ADDENDUM NO. 1

Improvements to Exterior and Replace VCT Flooring Shady Grove State School Poplar Bluff, Missouri PROJECT NO.: E2405-01

Bidders are hereby informed that the construction Plans and/or Specifications are modified as follows:

DRAWING INDEX SITE LOCATION PLANS LEGENDS AND **ABBREVIATIONS**

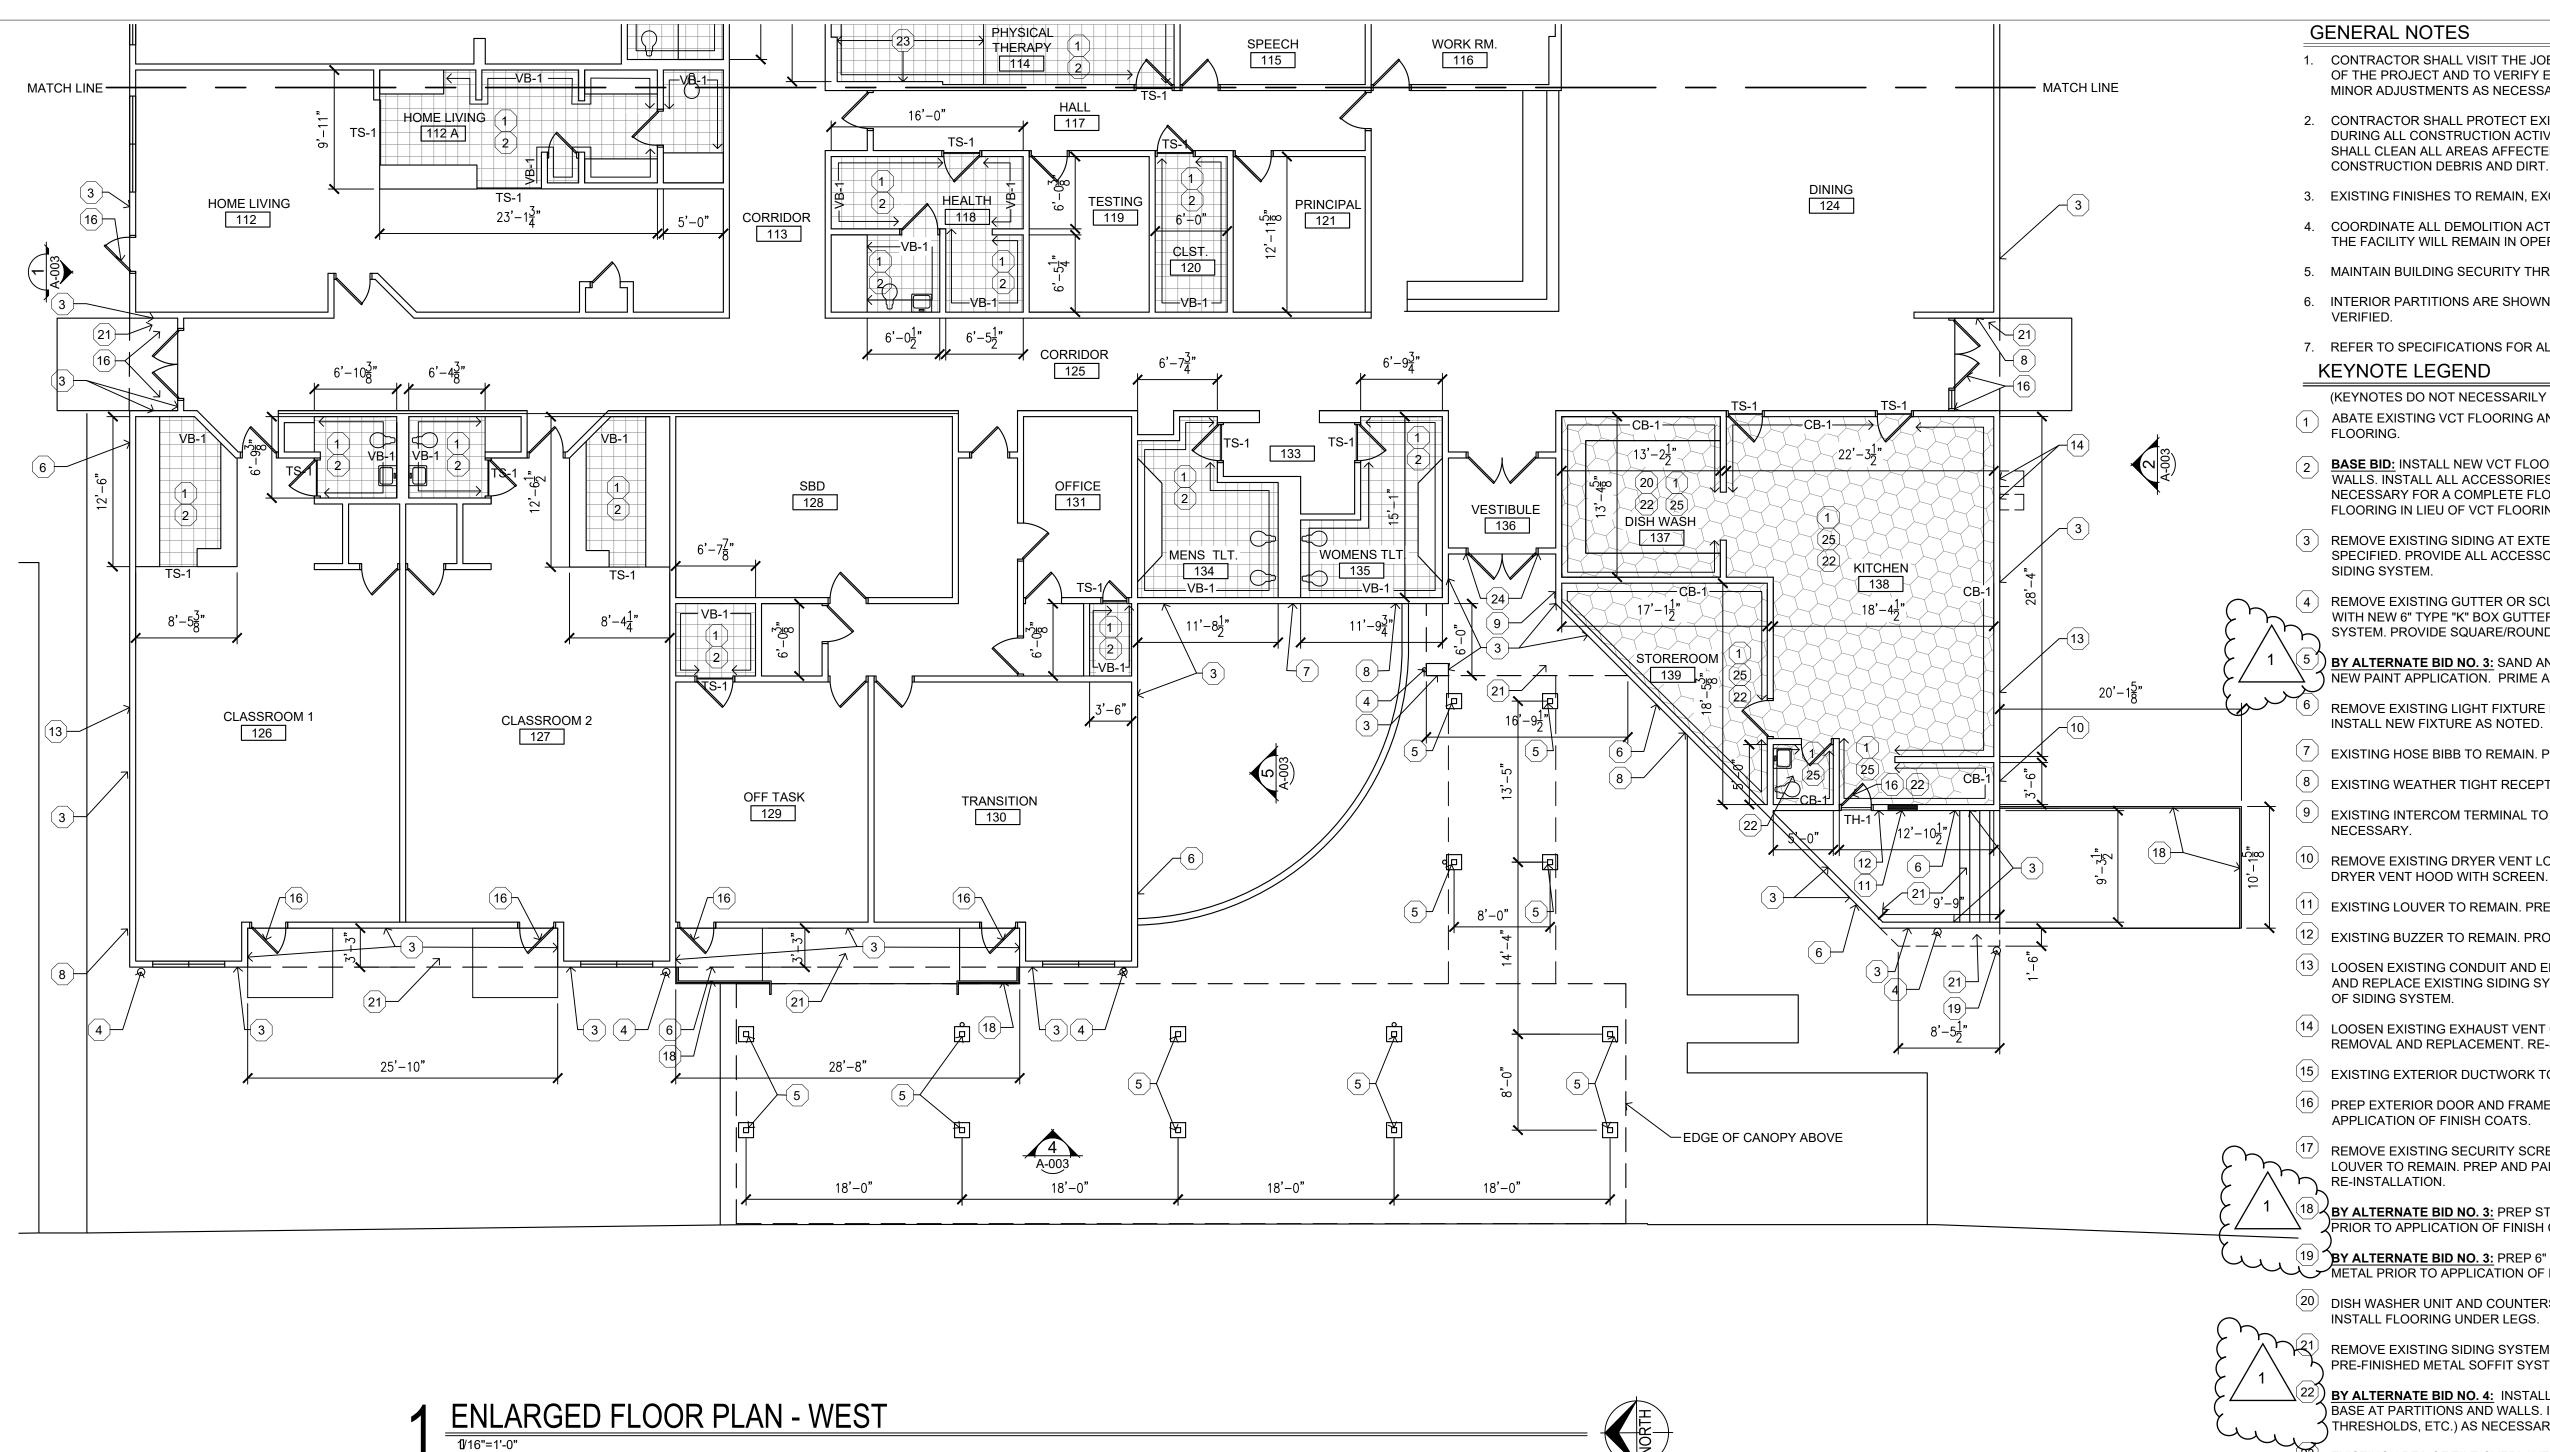
- 1. SHEET G-002
 - a. REVISE Scope of Work to update Alternate numbers. See attached revised drawing.
- 2. SHEET A-101
 - a. REVISE Key Notes 5, 18, 19, 22, and 26 to update Alternate numbers. See attached revised drawing.
- 3. SHEET A-102
 - a. REVISE Key Notes 5, 18, 19, 22, and 26 to update Alternate numbers. See attached revised drawing.

A. PER THE SUMMARY OF WORK, THE PROJECT CONSISTS OF IMPROVEMENTS TO THE EXTERIOR AND INTERIOR OF THE SHADY GROVE STATE SCHOOL. THE SCOPE OF WORK INCLUDES, BUT IS NOT LIMITED TO, REMOVAL AND REPLACEMENT OF EXISTING EXTERIOR SIDING SYSTEMS AND SOFFIT AND ABATEMENT OF INTERIOR EXISTING FLOOR TILE AND MASTIC WITH REPLACEMENT OF FLOORING SYSTEMS. B. ALTERNATE NO. 1 IS AN ADD TO UPGRADE VCT-1 FLOOR TILE TO LVT FLOORING AS

SPECIFIED. $\ \ \mathsf{C}.\ \mathsf{A}\mathsf{A}\mathsf{L}\mathsf{TERNATE}\ \mathsf{NO}.\ \mathsf{3}\ \mathsf{IS}\ \mathsf{AN}\ \mathsf{ADD}\ \mathsf{TO}\ \mathsf{PROVIDE}\ \mathsf{PREP},\ \mathsf{PRIME}\ \mathsf{AND}\ \mathsf{NEW}\ \mathsf{PAINTED}\ \mathsf{FINISH}\ \mathsf{TO}\ \mathsf{PROVIDE}\ \mathsf{PREP}$ THE EXTERIOR STRUCTURAL STEEL FRAMING OF THE EXISTING CANOPY AT THE BUILDING'S FRONT ENTRY. WORK INCLUDES ALL STEEL HANDRAILS, POSTS AND BOLLARDS.

D. ALTERNATE NO. 4 IS AN ADD TO UPGRADE HEAVY DUTY SAFETY SHEET FLOORING IN THE KITCHEN AND DISH WASH TO RESINOUS FLOORING. THE KITCHEN AND DISH WASH TO RESINOUS I LOOKING.

E.) ALTERNATE NO. 2 IS AN ADD TO UPGRADE VCT-1 FLOOR TILE TO SPORT FLOORING IN THE MULTI-PURPOSE ROOM ONLY.

A-301

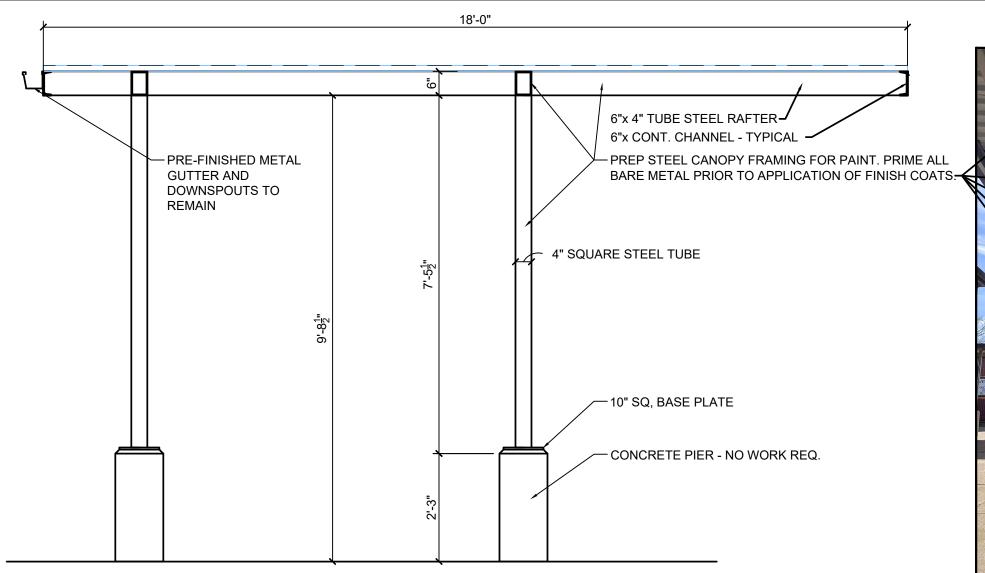
4. SHEET A-301

a. REVISE Key Notes 5, 18, and 19 to update Alternate number. See attached revised drawing.

1 DRIVE CANOPY SECTION - ALL WORK BY ALTERNATE BID NO 3

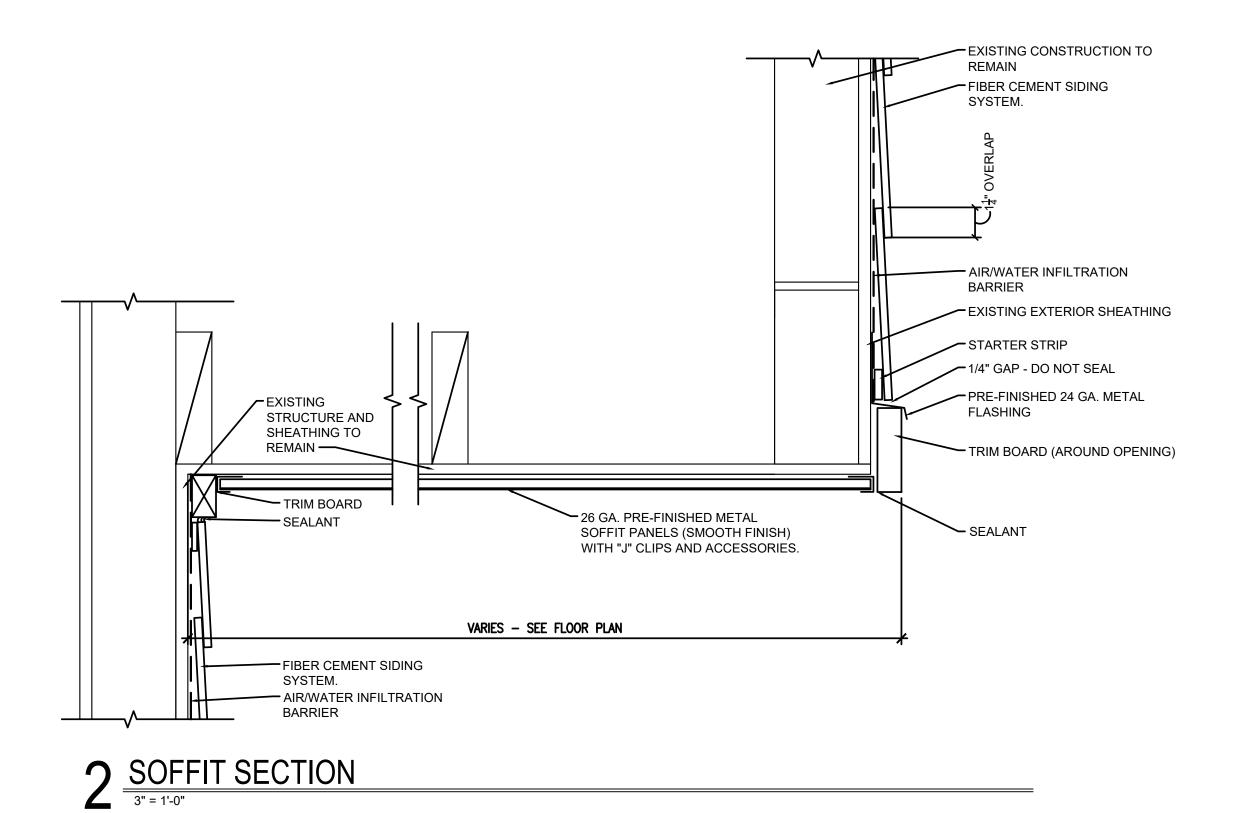
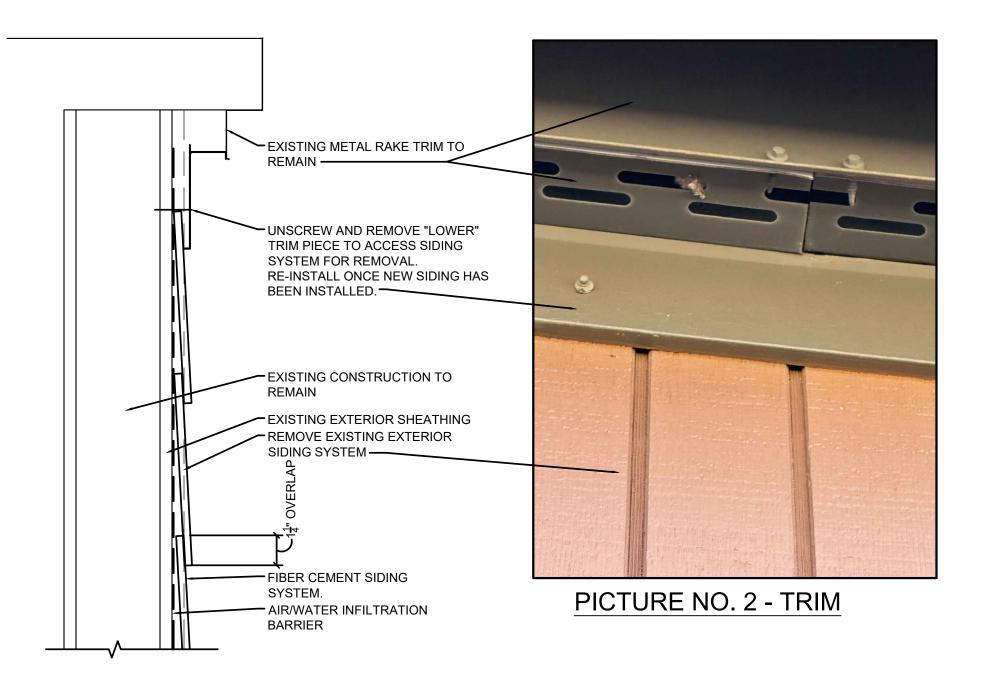
5. SHEET A-401

a. REVISE Detail 1 to update Alternate number. See attached revised drawing.
